Service Bulletin No. 49

Model: TA-4650, -5650

Subject: V-FET Replacement

Subject: V-FET Replacement

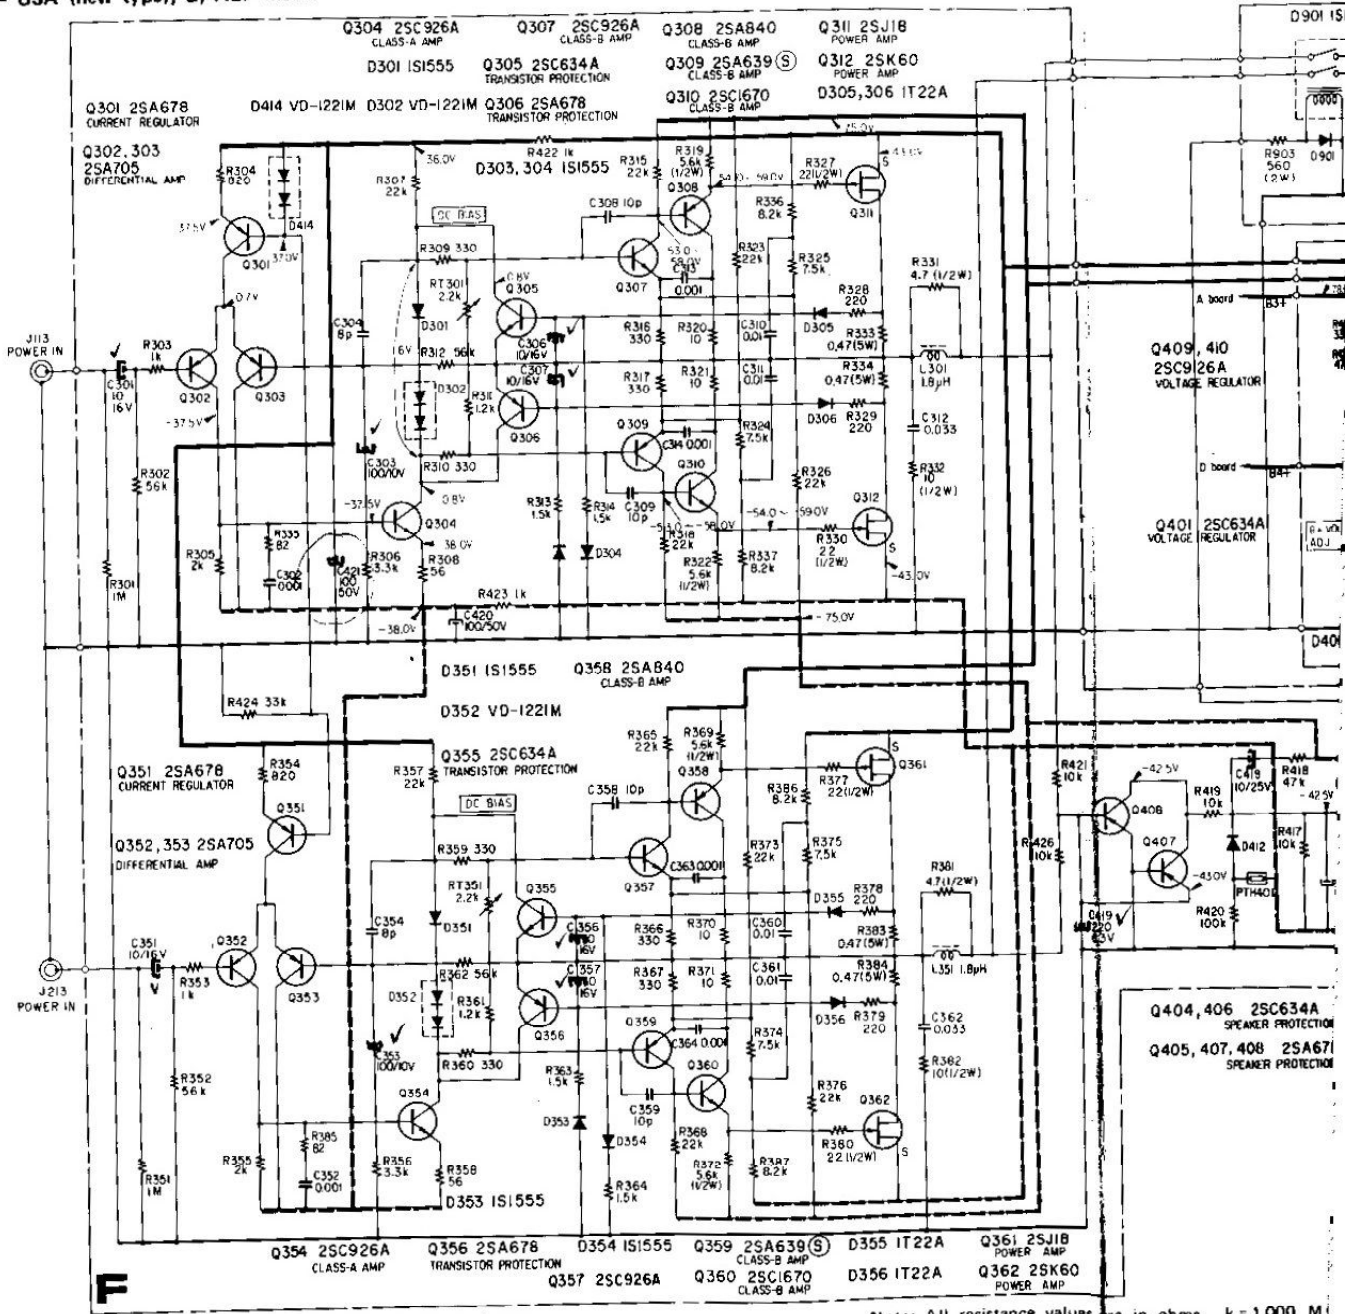
1. Turn off the power and remove the suspect V-FET.
2. Check resistance readings of this V-FET using a VOM set to the $X1\Omega$ range. See illustration below.

S to D ----- Approx. $1\sim 2\Omega$

S to G ----- Same as a diode

D to G ----- Same as a diode
